SERVICE BULLETIN

NUMBER: 03-001-15 REV. A

SUBJECT:
Rear Half Shaft Vibration

2015	(LX)	Chrysler 300
2015	(LD)	Dodge Charger
2015	(LA)	Dodge Challenger

Fig. 1 Identification Label Location

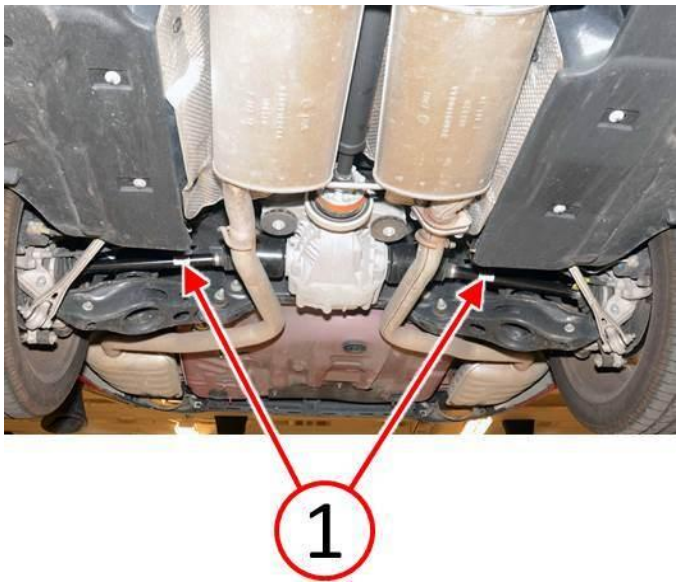
REPAIR PROCEDURE:
1. **Raise the vehicle and locate the axle shaft identification labels (1) (Fig. 1). Refer to the detailed service procedures available in DealerCONNECT> TechCONNECT under: Service Info> 04 - Vehicle Quick Reference> Hoisting> Standard Procedure.**

Fig. 2 Identification Label Information

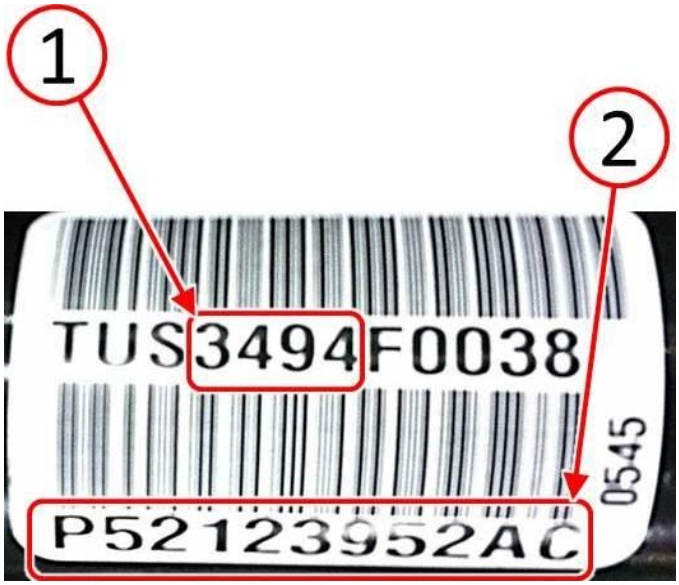
2. **Inspect the affected date code range (1) on both axle shaft identification labels (Fig. 2).**

3. **Is the affected date code range any number between 3094 through 3384?

a. YES>>> Continue with the Repair Procedure Step #4.
b. NO>>> This bulletin has been completed, use LOP (03-20-03-92) to close the active RRT. If the customer described the symptom/condition listed above, normal diagnosis should be performed.**

4. Replace both rear half shafts. Refer to the detailed service procedures available in DealerCONNECT> TechCONNECT under: Service Info> 02 - Differential and Driveline> Half Shaft> Removal/Installation.
